In the Matter of: Entergy Nuclear Operations, Inc.  
(Indian Point Nuclear Generating Units 2 and 3)

10 -----X  
11 PRE-FILED SUPPLEMENTAL REPLY WRITTEN TESTIMONY OF

12 Dr. RICHARD T. LAHEY, JR.

13 REGARDING CONTENTION NYS-25

**Figure 1:** Comparison of Limit Line (LL) and Best Estimate (BE) predictions, with embrittlement (BE<sub>e</sub>) and without embrittlement (BE<sub>ne</sub>).

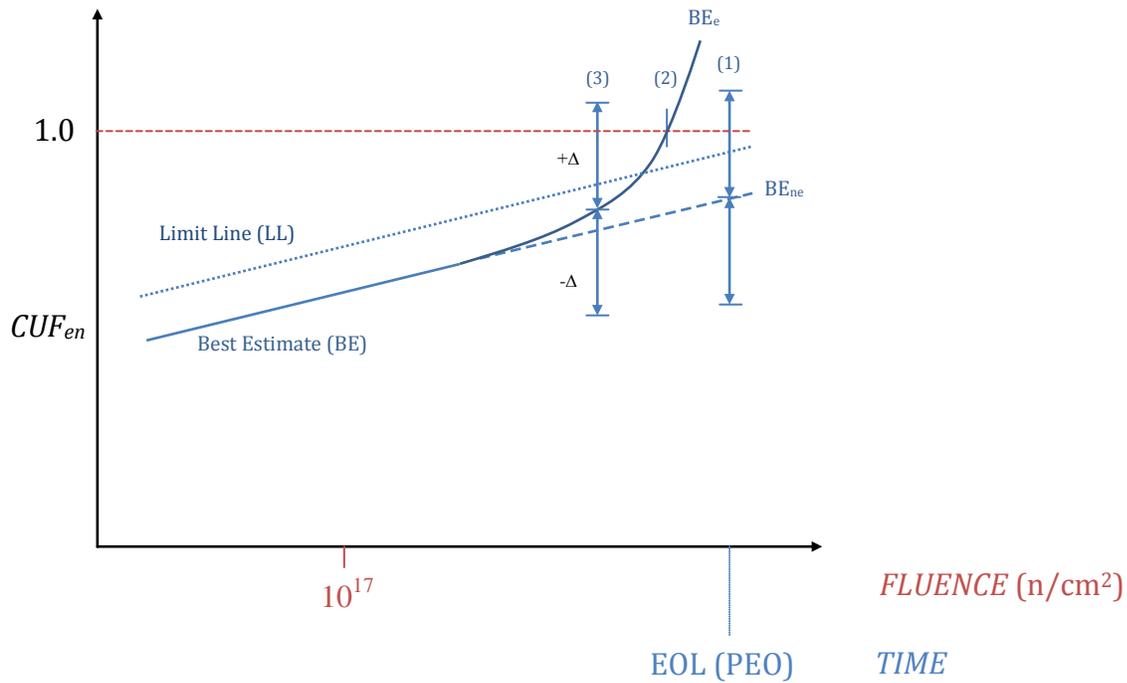
2 A. I prepared this Figure to visually illustrate some of  
 3 the concerns that I have set forth in my testimony in this  
 4 proceeding. Specifically, this Figure shows three important  
 5 things: (1) a typical WESTEMS™ "Limit Line" prediction, (2) a  
 6 "Best Estimate" prediction of CUF<sub>en</sub>, the cumulative usage factor  
 7 under reactor operating conditions, and the associated

1 uncertainty interval ( $\Delta$ ), and, (3) how the neutron fluence-  
2 induced embrittlement of a RVI structure, component, or fitting  
3 can dramatically increase the possibility of a fatigue failure,  
4 as represented by the cumulative usage factor under PWR  
5 operating conditions,  $CUF_{en}$ , being equal to unity. This figure  
6 applies to RVI structures, components, and fittings made of  
7 stainless steel or other materials. In summary, in Figure-1, I  
8 have illustrated two different approaches for calculating a  
9 time-dependent  $CUF_{en}$ , namely the "Limit Line" and the "Best  
10 Estimate" calculation. For the "Best Estimate" line, I also  
11 illustrate typical uncertainty intervals, delta ( $\Delta$ ), and the  
12 effects of fatigue on embrittled (e) and on non-embrittled (ne)  
13 RVIs.

17 [REDACTED]  
18 [REDACTED] The "Limit Line" shown in Figure-1 includes  
19 Entergy's implicit assumption that a stainless steel RVI  
20 structure, component, or fitting remains perfectly ductile, and  
21 thus shows that the  $CUF_{en}$  for a RVI will increase with an  
22 increasing number of fatigue cycles, but that it is not affected  
23 by the fluence. The "Limit Line", therefore, uniformly

1 increases in  $CUF_{en}$  even after the fluence exceeds  $10^{17}$  n/cm<sup>2</sup>,  
2 where significant embrittlement begins to develop (i.e., it is  
3 assumed that the number of cycles to failure are not a function  
4 of fluence). Figure-1 shows that, as the RVI component  
5 approaches the end of life (EOL) for the period of extended  
6 operation (PEO), [REDACTED] "Limit Line" will approach  
7 (but still be below)  $CUF_{en} = 1.0$ . This is depicted as location  
8 (1).

11 A. Not necessarily. As shown in Figure-1, a "Best  
12 Estimate" prediction plus the uncertainty ( $\Delta$ ) may predict  
13 possible RVI structure, components or fitting failures (i.e.,  
14  $CUF_{en} = 1.0$ ), sooner than the "Limit Line" would. Moreover, the  
15 effect of embrittlement can make the situation much worse. The  
16 problem is that no one knows how much conservatism, if any, is  
17 in the [REDACTED] "Limit Line". As a consequence, we can have no  
18 confidence that "Limit Line" results near  $CUF_{en} = 1.0$ , are  
19 sufficiently conservative to bound all the possible  
20 uncertainties, as illustrated in Figure-1 by  $\Delta$ .

20 A. Location (1) shows that, even if embrittlement is not  
21 considered, RVI fatigue failure may occur by the end of life for  
22 the period of extended operation. This is because the sum of a

1 "Best Estimate" prediction plus the uncertainty interval ( $\Delta$ )  
2 associated with this prediction would exceed  $CUF_{en} = 1.0$ . In this  
3 case the "Limit Line" result is clearly non-conservative.

6 A. Location (2) shows that embrittlement can result in  
7 the physical failure of the RVI well before the end of life for  
8 the period of extended operation.

11 A. At location (3), the "Best Estimate" plus uncertainty  
12 ( $\Delta$ ) for the case considering embrittlement ( $BE_e$ ) predicts  
13 possible failure of the hypothetical RVI component well before  
14 the end of life for the period of extended operation, even  
15 though the "Limit Line" prediction indicates substantial margin  
16 to failure at this point. That is, at location (3) the  $CUF_{en}$  for  
17 the "Best Estimate" line, accounting for embrittlement and for  
18 all uncertainties (i.e.,  $BE_e + \Delta$ ), exceeds unity. Moreover, as I  
19 have stated in my previous testimony, highly embrittled RVIs may  
20 fail even sooner than by fatigue alone if significant seismic or  
21 shock loads occur. That is, fatigue-weakened and embrittled  
22 structures cannot tolerate large impulsive seismic and shock  
23 loads like fully ductile structures can. Moreover, other

1 synergistic aging effects, such as the thermal embrittlement (TE)  
2 of some CASS RVIs (the upper part of the core support columns)  
3 would may move the  $BE_e$  curve to the left of its position shown in  
4 Figure-1 (i.e., the RVI would be predicted to reach failure,  
5  $CUF_{en} = 1.0$ , even sooner than the cases (2) and (3) in Figure-1).

8 A. Yes. Because of Entergy's failure to explicitly  
9 account for uncertainties, and for the effect of embrittlement  
10 on fatigued RVIs, we can have no confidence in the "Limit Line"  
11 type of  $CUF_{en}$  predictions [REDACTED]
